Agenda

Land Use Management Committee

Monday 2 July 2007

ATTACHMENT 1

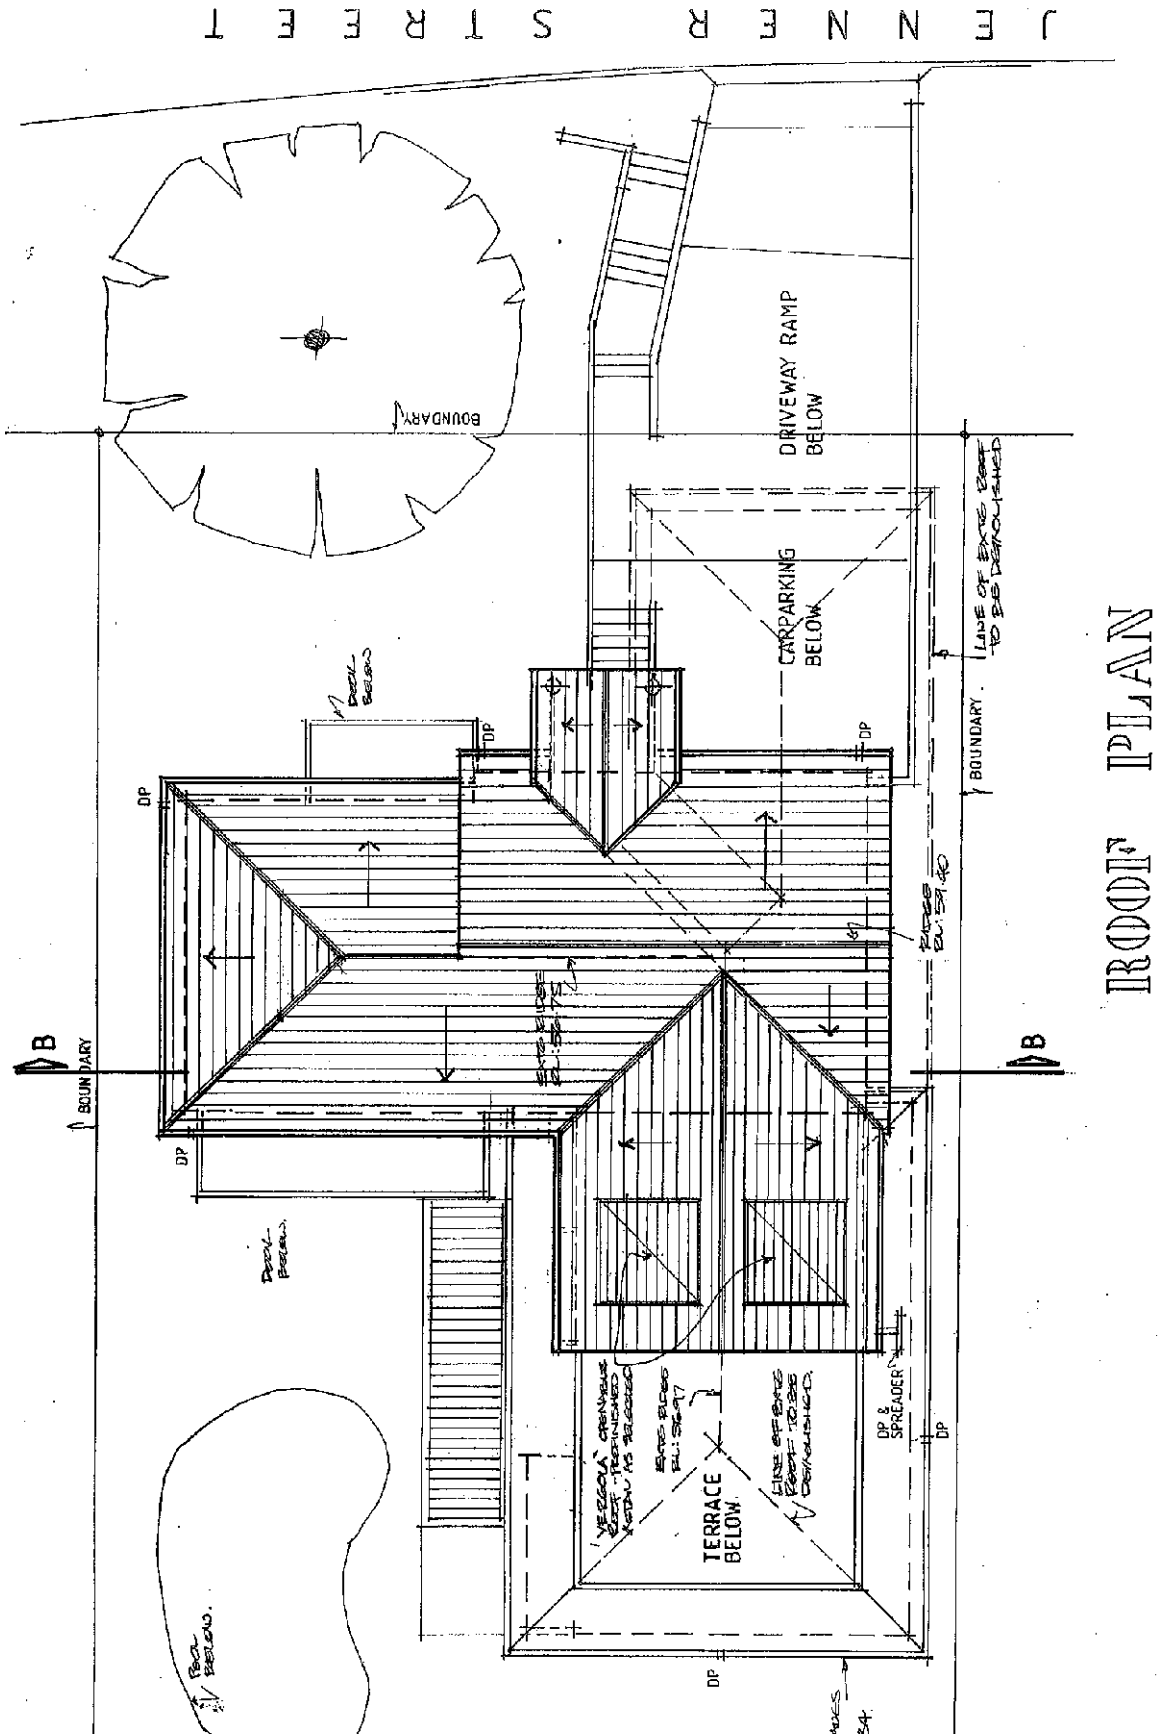
In response to this the owner, applicant/architect and owners solicitor have made written submissions, copies of which are attached to this report. The applicant states that a mono pitch roof would cause adverse visual impacts to the streetscape and cannot be proven to reduce view impacts. Reference is also made to the Tenacity Judgment and whether a mono-pitch roof would succeed in reducing view impacts. Without this being demonstrated, there is no justification to this argument with the view impact considered to be excessive. Consequently the proposal as amended is considered to remain unacceptable in terms of view loss with this being a primary reason for refusal.
